WAMBO COAL PTY LIMITED

SOUTH BATES EXTENSION MODIFICATION

RESPONSE TO SUBMISSIONS PART B

For the Modification of DA 305-7-2003 (MOD 17)
Extension of the Approved South Bates Underground Mine

Figure 1 – Predicted Total Stored Water Salinity

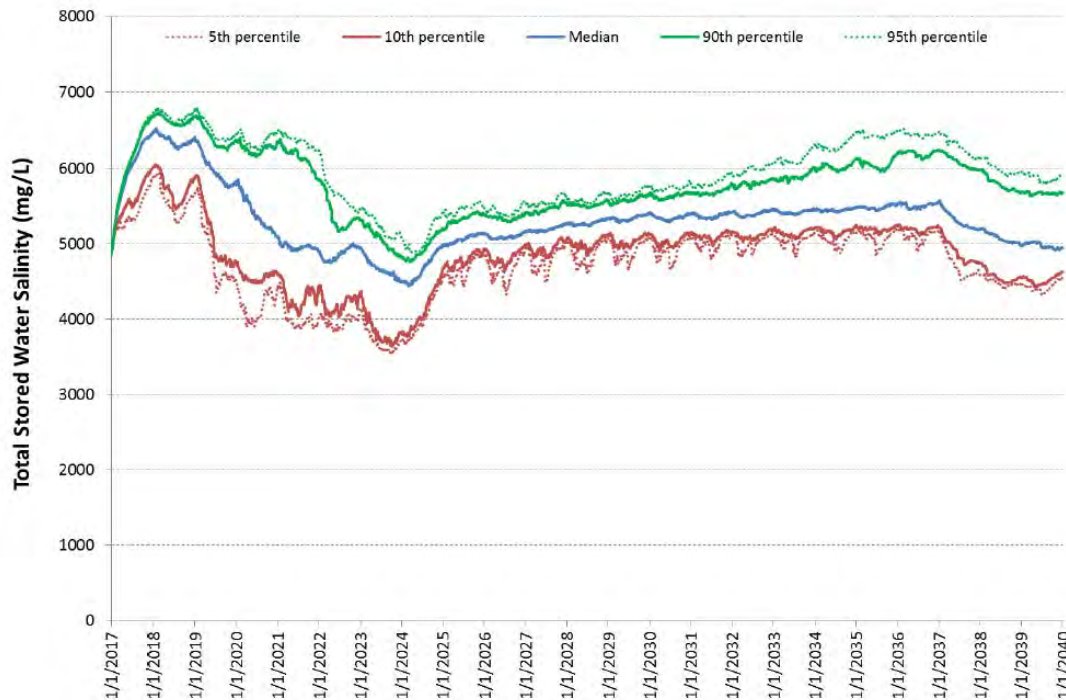
- water storages to be used by the Modification;
- the proposed purpose and management of each water storage;
- discharges and/or overflows from each water storage (including project-specific calculations of discharges); and
- the water quality of the water storages (including project-specific calculations of storage water quality/salt loads).

Figure 3 of the *Site Water Balance* (Appendix L of the EA) shows the water storages to be used by the Modification and where a storage may spill in the event that a storm event occurs that cannot be accommodated within the design criteria, site operating rules and pumping capacity.

The predicted salinity of water stored in all simulated water storages was presented by HEC (2017) in Appendix L of the EA, and is reproduced in Figure 1.

Figure 2

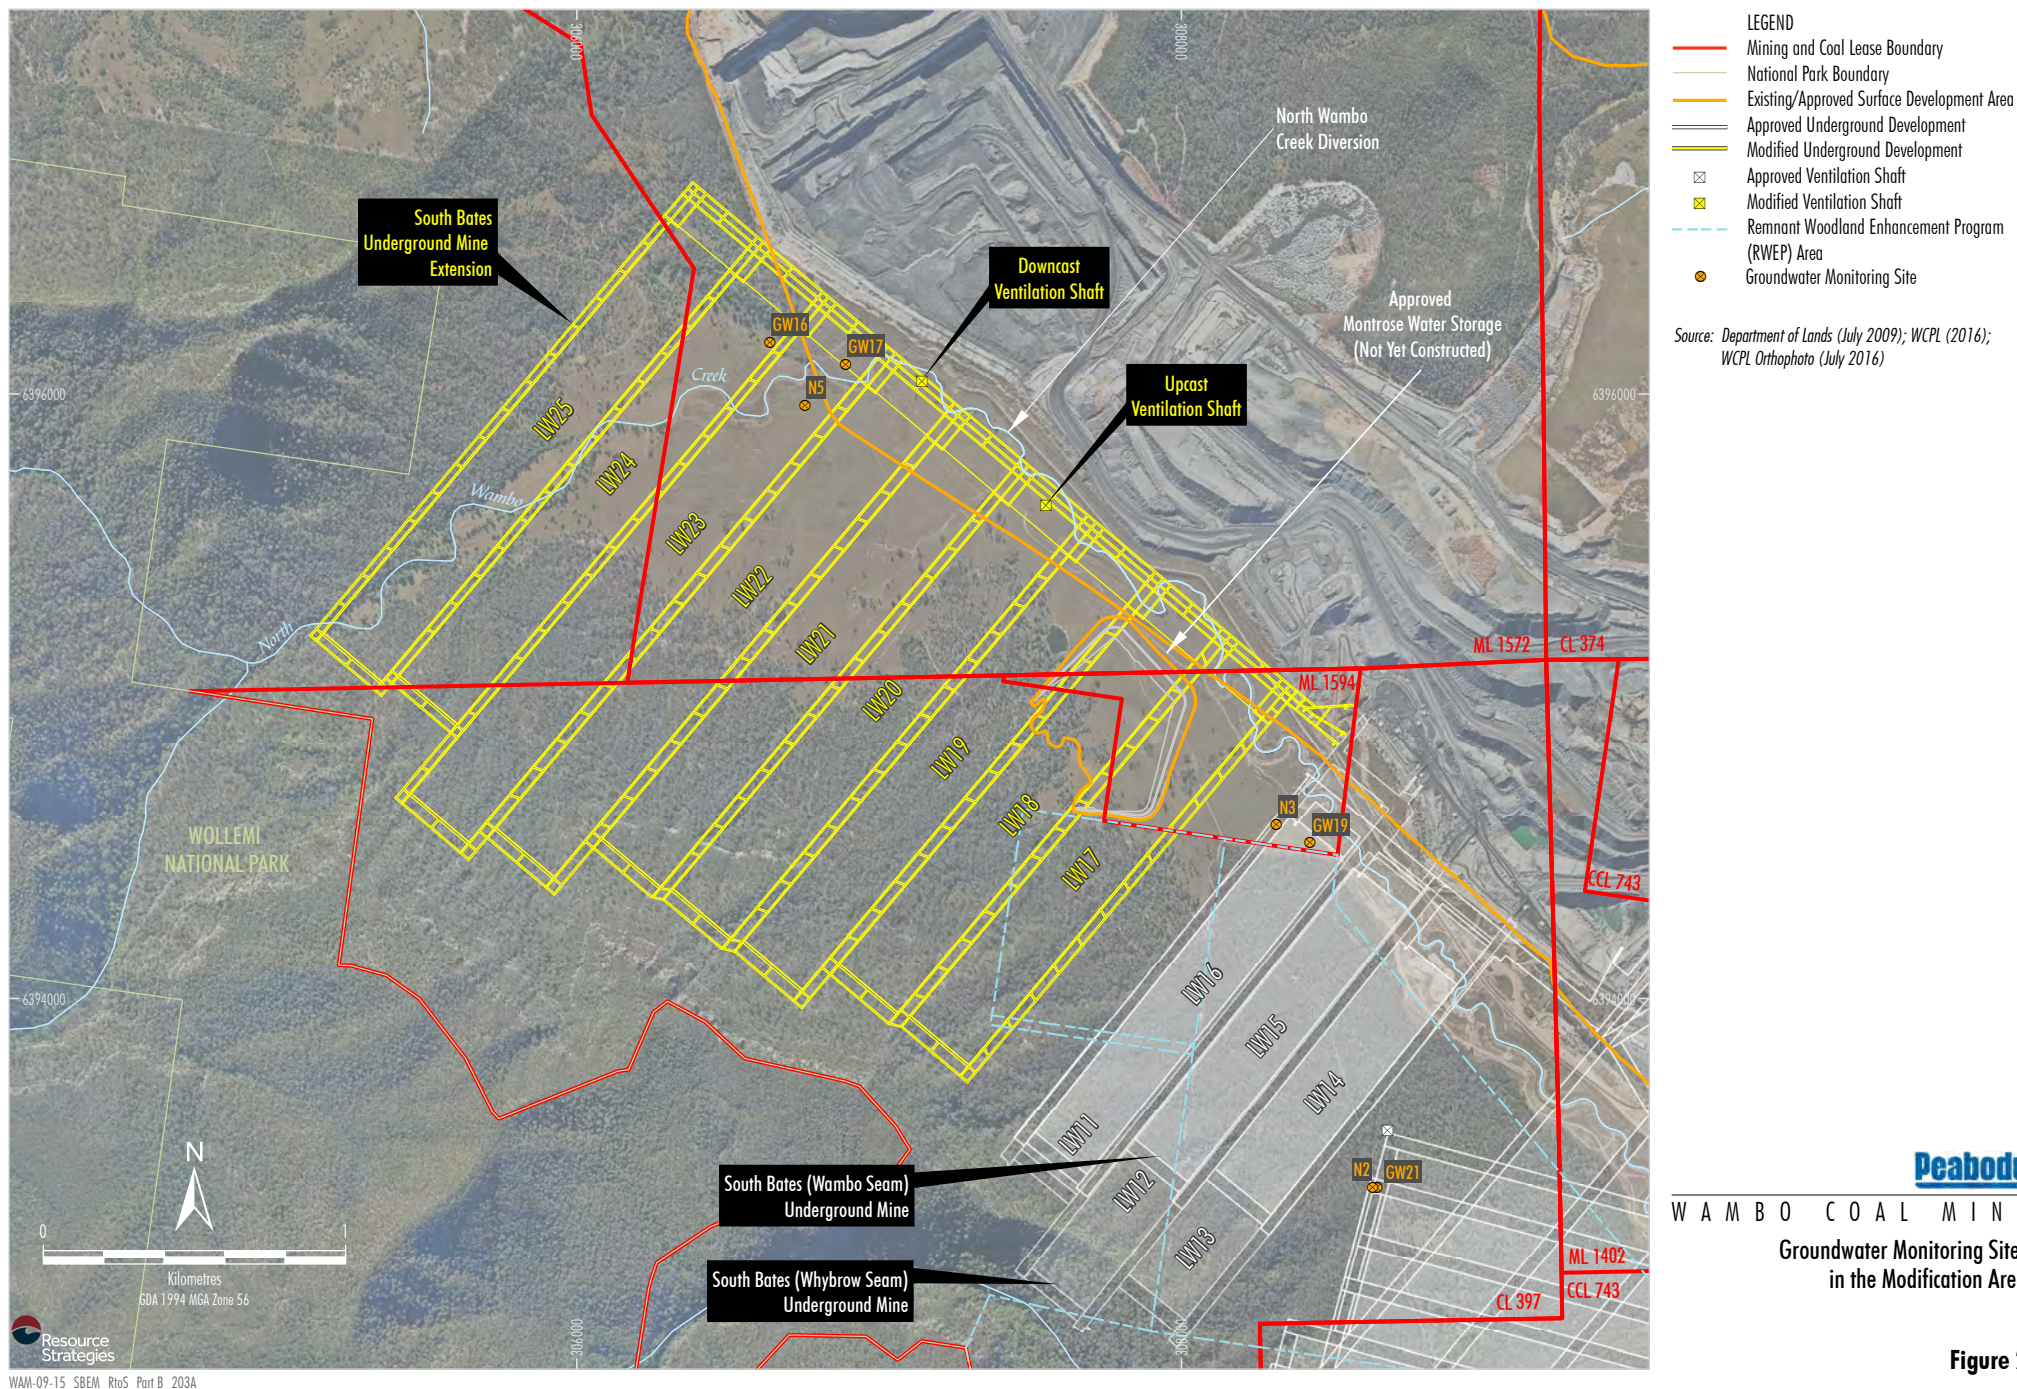
Several clustered bore sites and/or vibrating wire piezometers should be installed within the Porous Rock in the area above the proposed longwall panels within the Modification 17 project area. This installation must occur as soon as practical to supply baseline data. The sites selected should be both within and beyond the predicted area for connective fracture to surface and one site in proximity to mapped Critically Endangered Ecological Communities (CEEC). The full bore logs and downhole geophysics reports are to be provided to DPI Water. This drilling may then inform further investigation and a supplementary report on the pre-mining piezometric levels and water quality for all four coal seam aquifers, shallow interburden and, if present, the alluvial aquifer in proximity to the Hunter Lowland Redgum Forest.

As presented in the currently approved Extraction Plan for Longwalls 11 to 16, two multi-level vibrating wire piezometers (N2 and N3) are installed immediately adjacent to Longwalls 11 to 16 at South Bates Underground Mine to monitor changes in groundwater levels (Figure 2).

The DPI Water did not request additional monitoring sites above Longwalls 11 to 13 as part of its review of the Extraction Plan for Longwalls 11 to 13 in late 2015. The DPI Water received the complete Extraction Plan for Longwalls 11 to 16 in January 2017 and has not provided comment to date.

Figure 3a

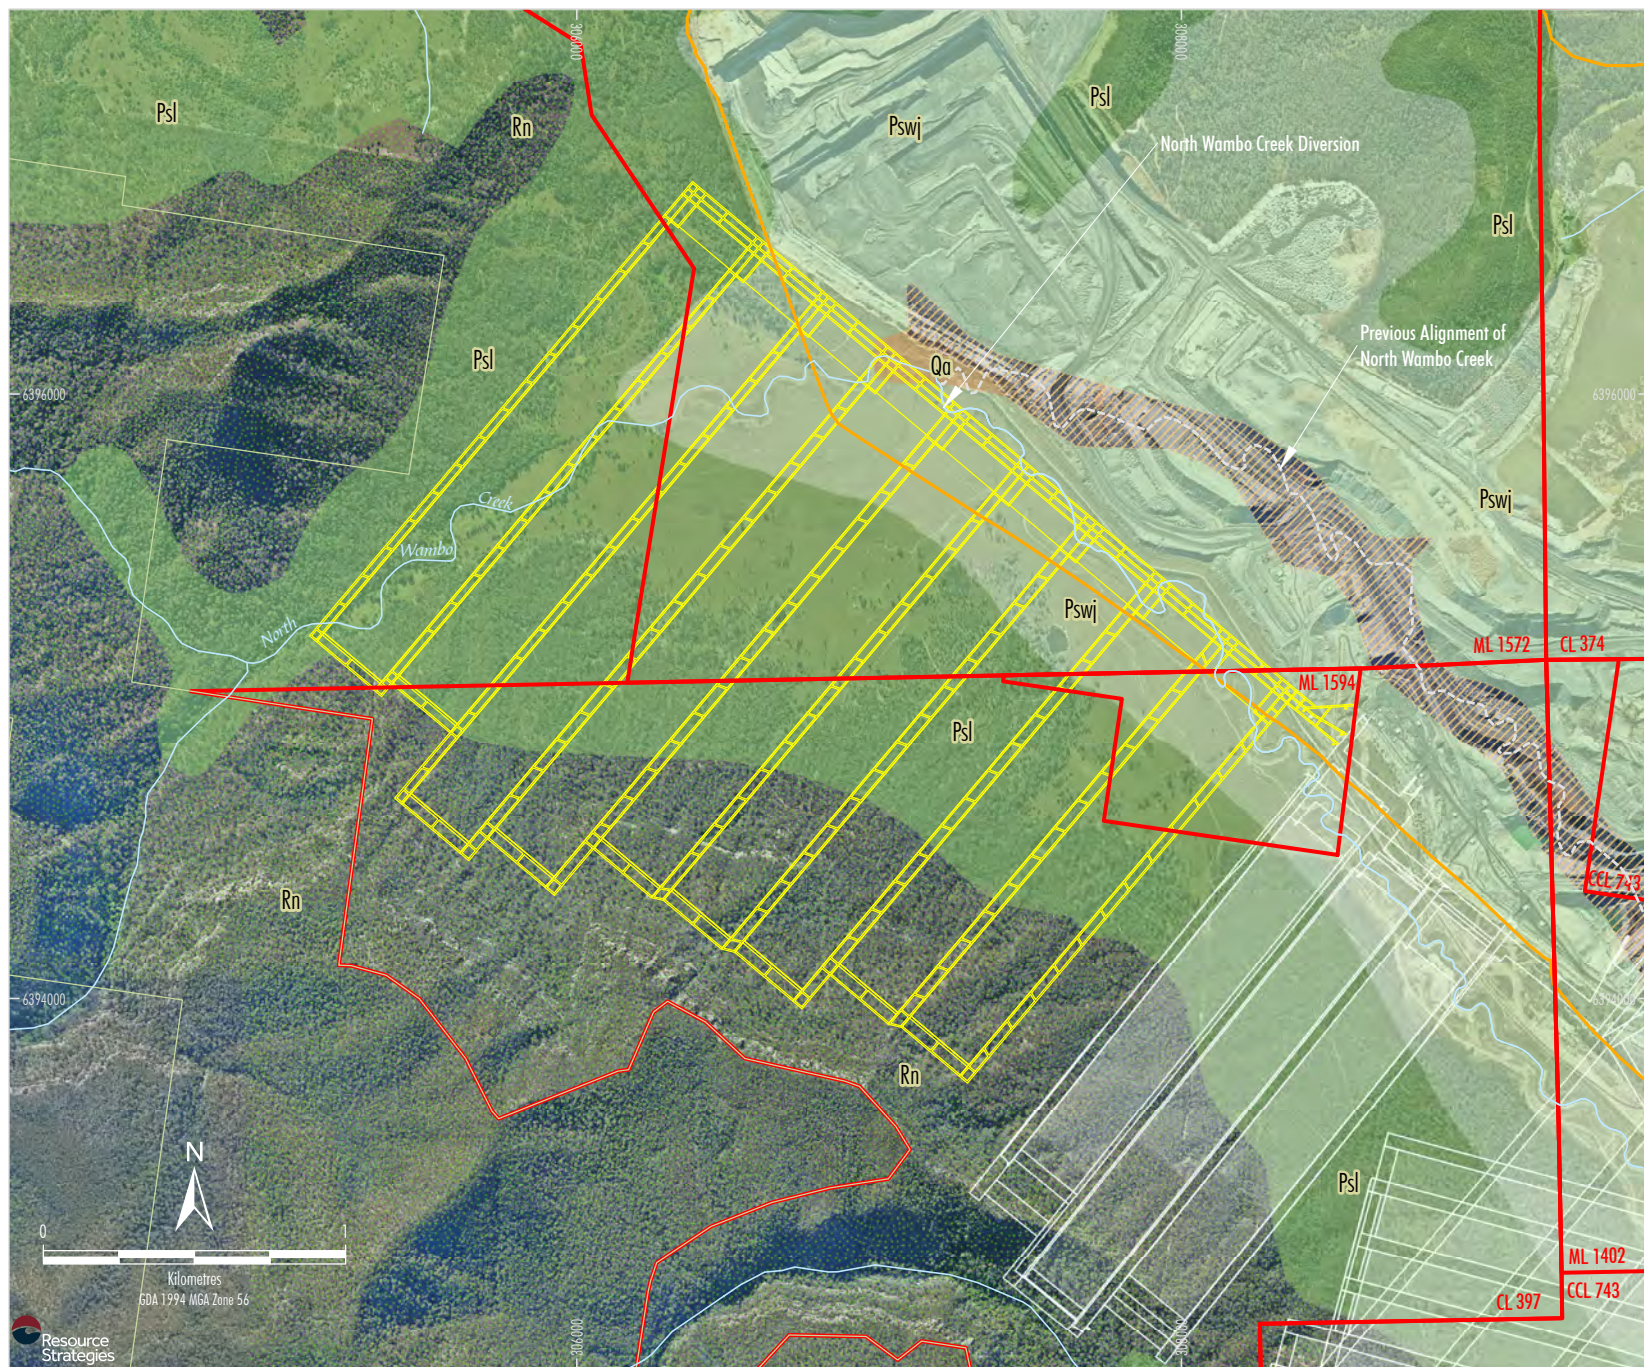
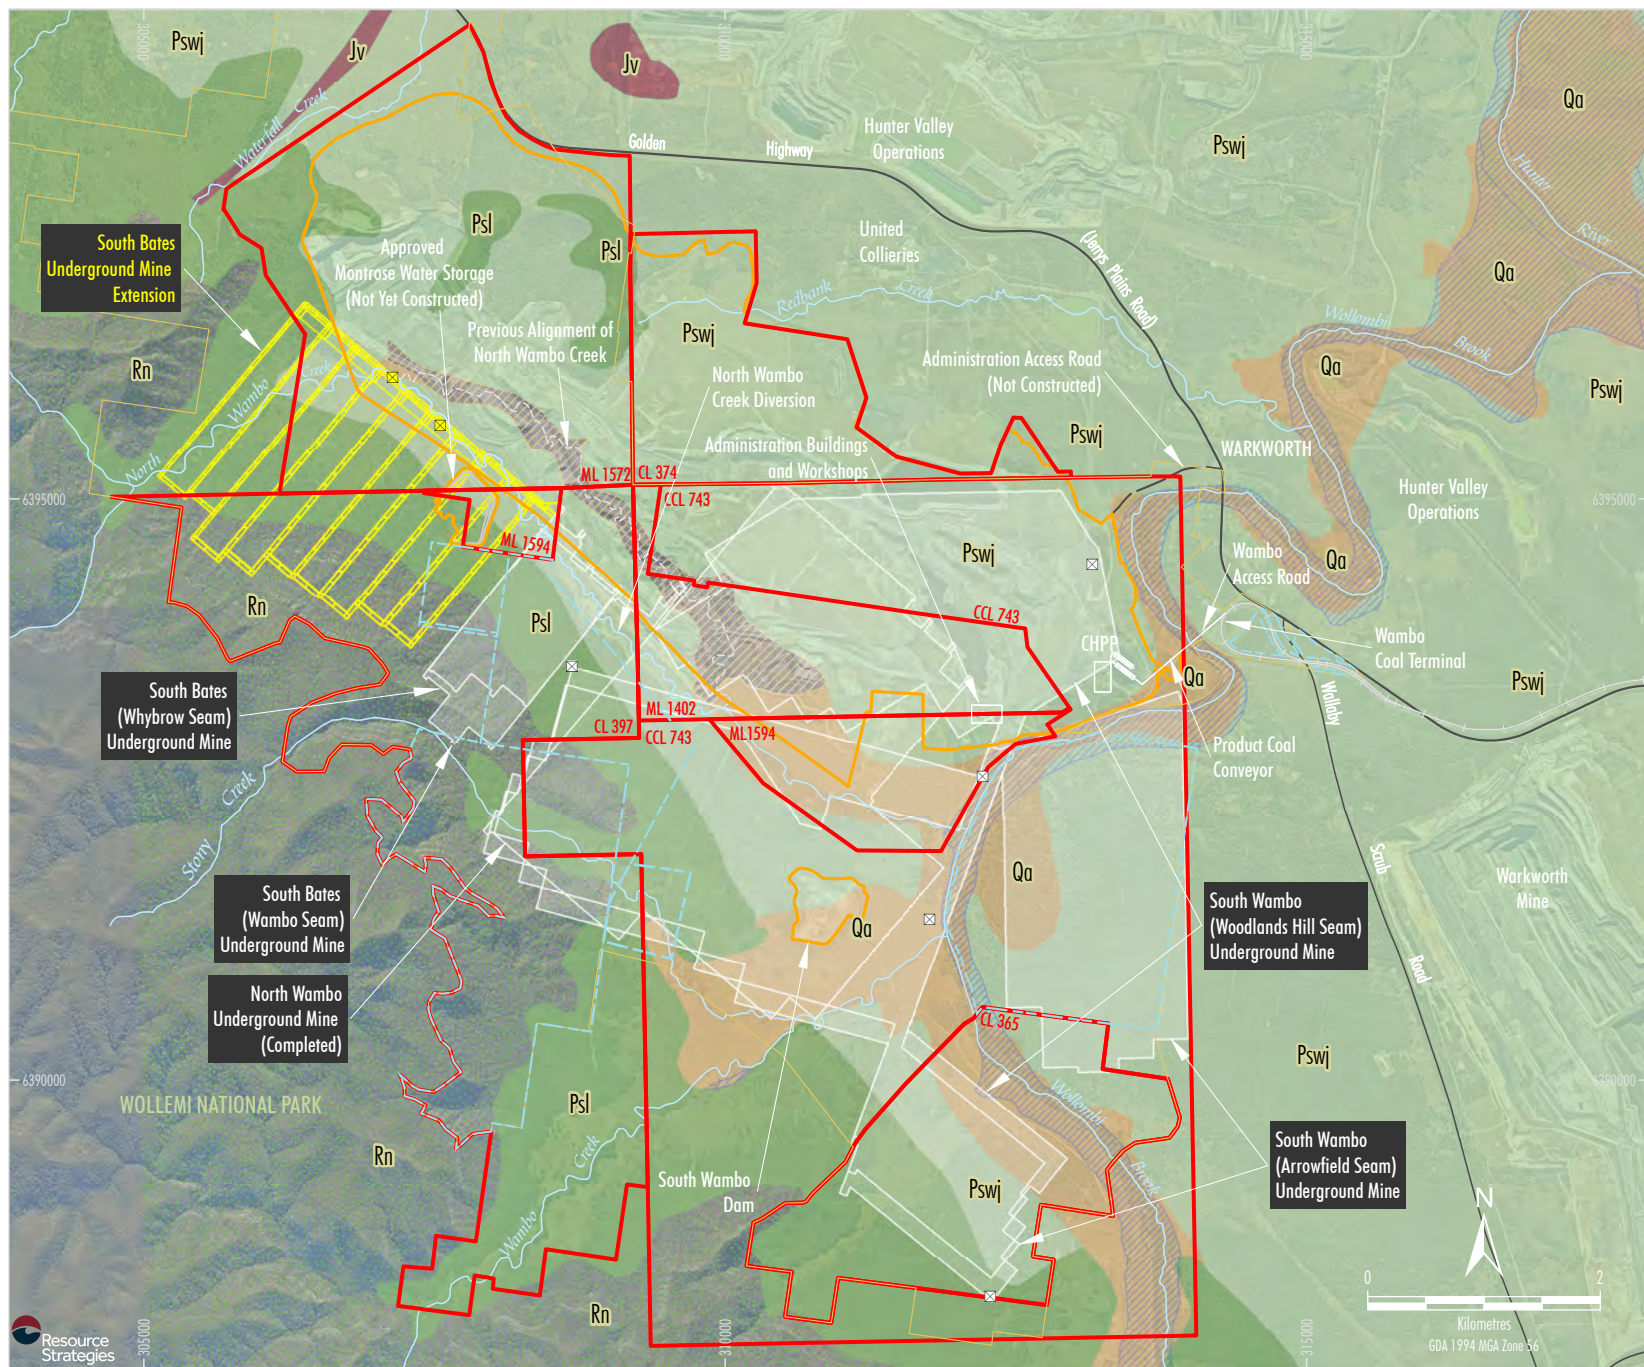
The IESC recommended monitoring for stygofauna at “multiple reference sites upstream” and in alluvial aquifers where no drawdown is predicted.

The shallow alluvial system located above the Modification longwalls is already in a highly modified state.

The alluvium above the Modification longwalls was once connected as part of a larger alluvial system associated with Wollombi Brook and its tributaries. The approved and existing Wambo open cut now forms an artificial barrier for any stygofauna present above the Modification longwalls (Figures 3a and 3b).

Given the alluvial system is now highly modified and fragmented, further assessment of stygofauna is not considered warranted.

There is no alluvium upstream of the Modification longwalls, and therefore there is not considered to be suitable stygofauna habitat for sampling or monitoring.
